### REGULAR MEETING OF THE DESIGN REVIEW BOARD

October 4, 2023 at 7:30 p.m.

7. **PUBLIC HEARING – 444 KEARNEY STREET TIER III DESIGN REVIEW**  
Application: PL22-0068  
Applicant: Robert Wolf  
Location: 444 Kearney St.  
APN: 504-510-026  
Zoning: Transit-Oriented Higher-Intensity Mixed Use (TOHIMU)  
General Plan: Transit-Oriented Higher-Intensity Mixed Use (TOHIMU)  
Request: Design Review Board consideration of Tier III Design Review for increasing the height of an existing structure by 6 feet and creating a live work unit.  
CEQA: This project is categorically exempt from the provisions of CEQA pursuant to Section 15332 of the CEQA Guidelines, Class 32: In-fill Development Projects.

**8. PUBLIC HEARING – REVISION TO 11690 SAN PABLO AVENUE (MAYFAIR AFFORDABLE)**

*Revised West Elevation*

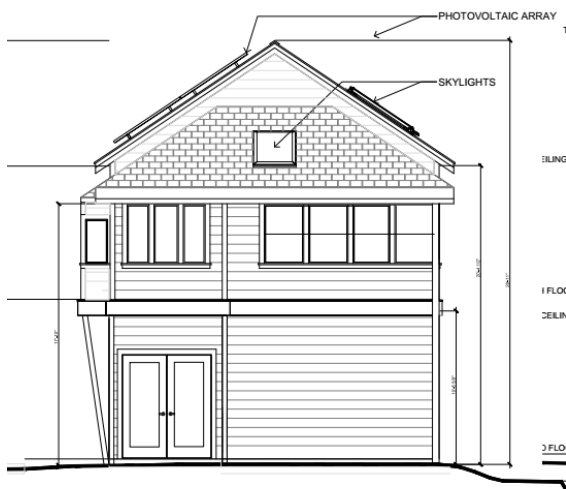
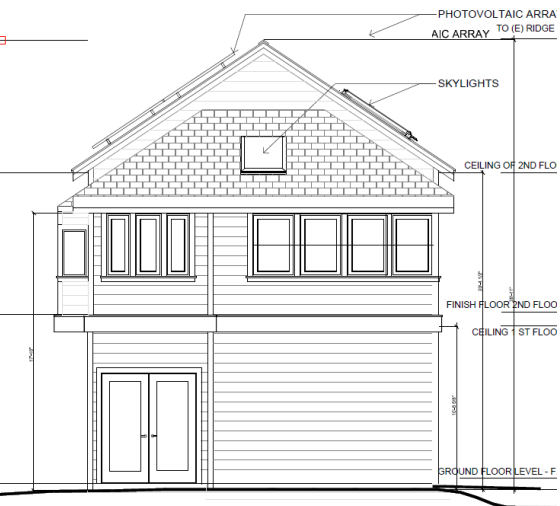
On June 7, 2023, the Design Review Board reviewed the application and continued the item to August 2, 2023. The applicant needed additional time to incorporate the changes requested by the Design Review Board, so the item was postponed to October 4, 2023. The Design Review Board directed the applicant to provide more detailed landscape plans, to provide elevations for any new proposed gates or fences, to consider a different porch design, and for the site plan to show all of the overhangs.

In response, the applicant provided a revised proposal addressing the points raised at the July 7, 2023 Design Review Board hearing. The applicant provided a revised landscape plan showing specific plants that are being proposed and the locations where they are being proposed. The current landscape plan is proposing the following plants: *Aloe pluridens* (French Aloe), *Comarostaphylis diversifolia* (Summer Holly), *Furcraea macdougallii* (MacDougall's Century Plant), *Garrya elliptica* (Silktassel Tree), *Prunus ilicifolia* (Catalina Cherry), *Rhus integrifolia* (Lemonade Berry), *Aloe plicatilis* (Fan Aloe), *Ceanothus 'Skylark'*, *Crassula ovata* (Jade Tree), *Cussonia spicata* (Cabbage Tree), *Aeonium arboretum* (Aeonium), *Aeonium simmsii* (Simm's Dwarf Aeonium), *Agave bracteosa* (Candelabrum Agave), *Eriogonum Grande V rubescens* (Red-Flowered Buckwheat), *Kalanchoe fedtschenkoi* (Lavander scalops), and *Iris douglasiana* (Douglas Iris). The applicant also provided a revised site plan which more acutely matches the proposed elevations and included elevations for the proposed gate design along Central Avenue. The applicant also revised the porch design so that it now includes a gabled roof, and they provided more information on the proposed windows which are Sierra Pacific Aluminum Clad windows. The images below show a comparison of the previously proposed elevations and the revised elevations. Proposed landscape changes can be seen on Sheet L2.1 and L2.2 of the attached plans.
